SUBJECT: AMENDMENT NOS. 89 AND 82 TO FACILITY OPERATING LICENSE NOS. DPR-42
AND DPR-60: (TAC NOS. 71536 AND 71537)

PRAIRIE ISLAND NUCLEAR GENERATING PLANT, UNIT NO. 1

PRAIRIE ISLAND NUCLEAR GENERATING PLANT, UNIT NO. 2

SAFETY EVALUATION BY THE OFFICE OF NUCLEAR REACTOR REGULATION

FIGURE TS 3.1-1

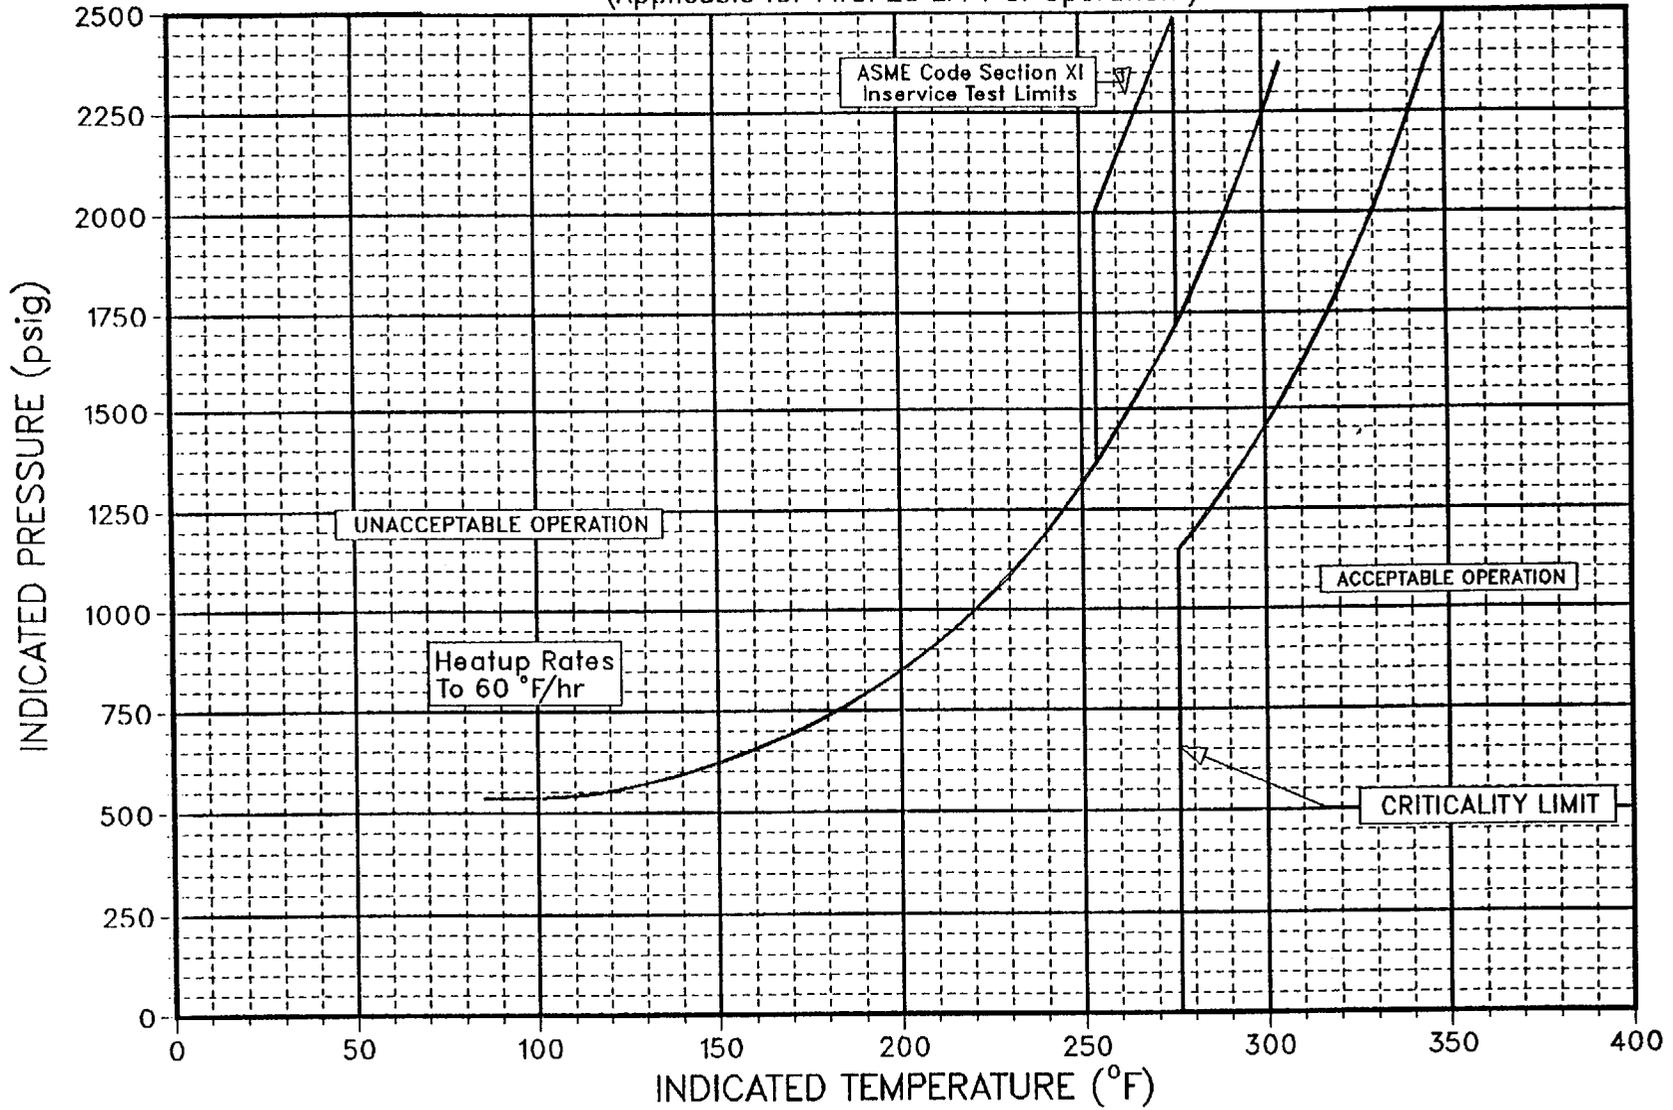
1. The effective limitation of existing reactor coolant system heatup and cooldown curves are revised from 15 to 20 effective full power years.
2. The word "vessel" appearing in TS.3.1.B3 is replaced with the phrase "steam generator shell."

UNIT 1 and UNIT 2
REACTOR COOLANT SYSTEM HEAT UP LIMITATIONS
(Applicable for First 20 EFY of Operation)

The licensee used the method in RG 1.99, Rev. 2, to calculate an ART of 144.8°F for the limiting weld metal in the beltline of Unit 2. We performed a similar calculation and verified the licensee's ART value to be conservative (see Table 1). Substituting the ART of 144.8°F into equations in SRP 5.3.2, we verified that the proposed P/T limits for heatup, cooldown, criticality, and hydrotest meet the beltline material requirements in Appendix G to 10 CFR Part 50.

Based on the above evaluation, the staff concludes that the proposed P/T limits on the reactor coolant system for heatup, cooldown, leak test, and criticality are valid through 20 EFPY, because the limits conform to requirements of Appendices G and H to 10 CFR Part 50. The licensee's submittal also satisfies Generic Letter 88-11, because the licensee used the method in RG 1.99, Rev. 2, to calculate the ART. Hence, the proposed P/T limits that would be incorporated into the PINGP-1 and PINGP-2 Technical Specifications are acceptable.

FIGURE TS 3.1-2

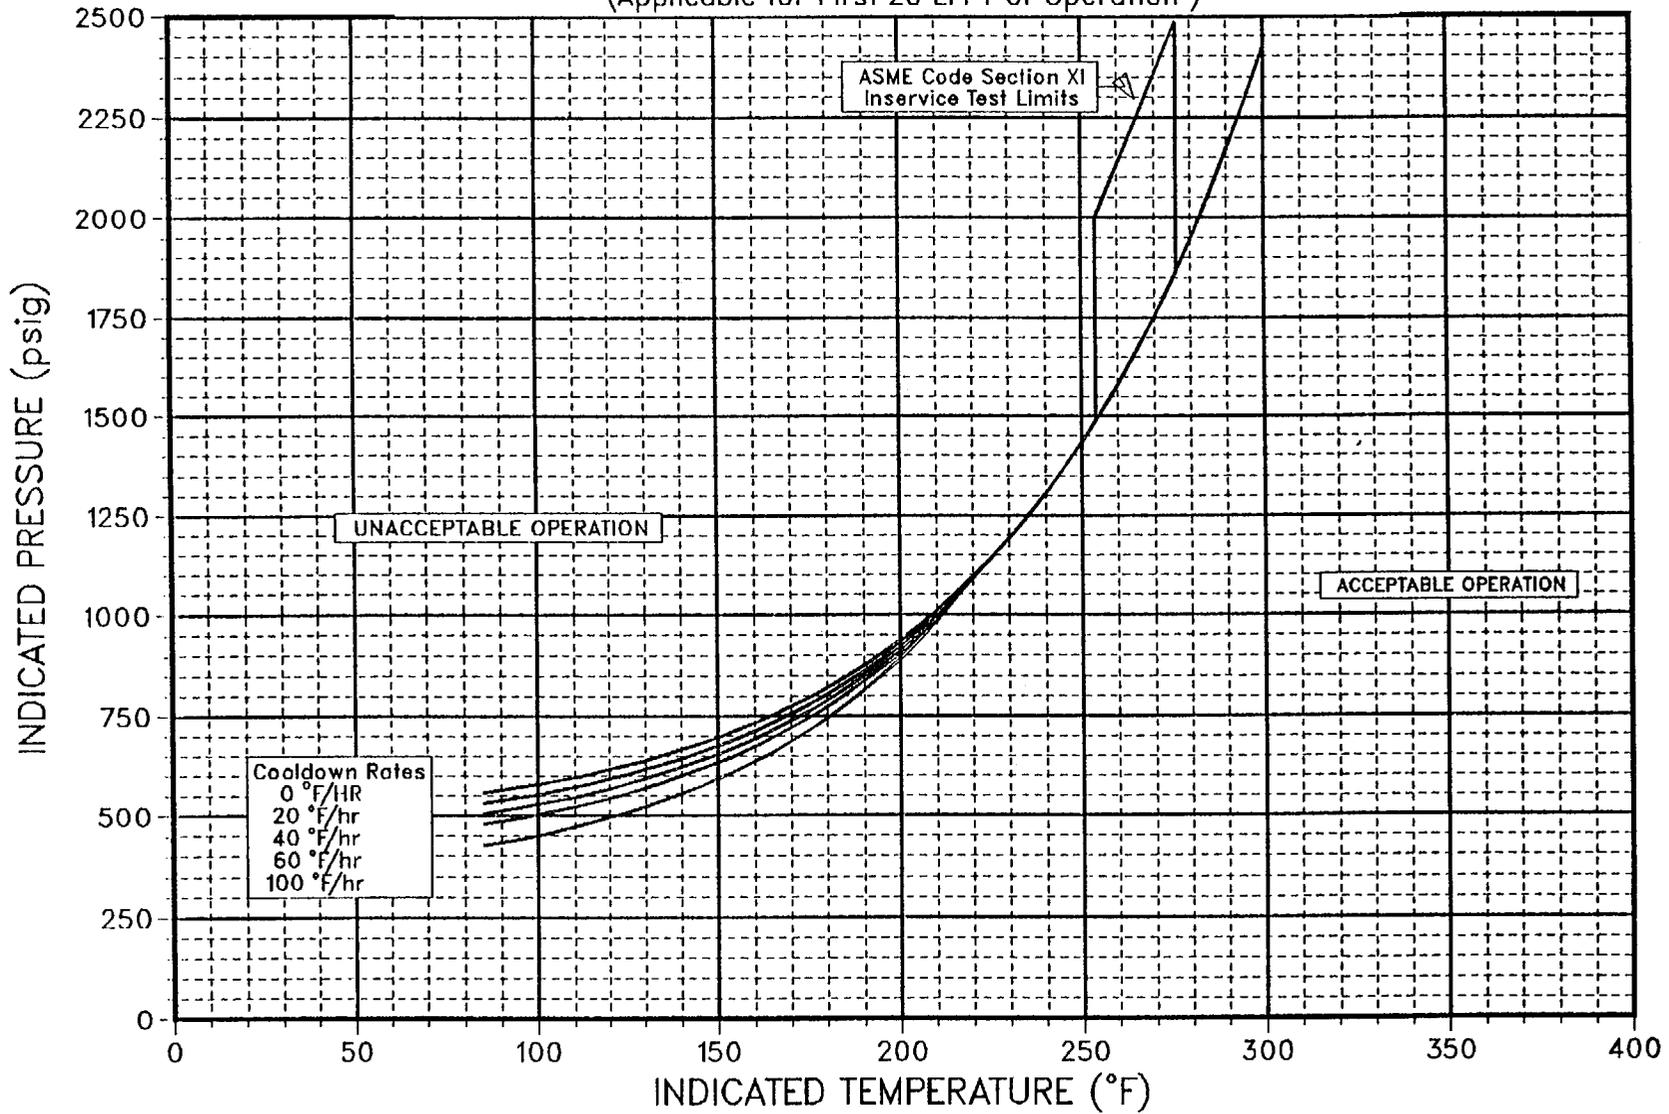
UNIT 1 and UNIT 2
REACTOR COOLANT SYSTEM COOLDOWN LIMITATIONS
(Applicable for First 20 EFY of Operation)
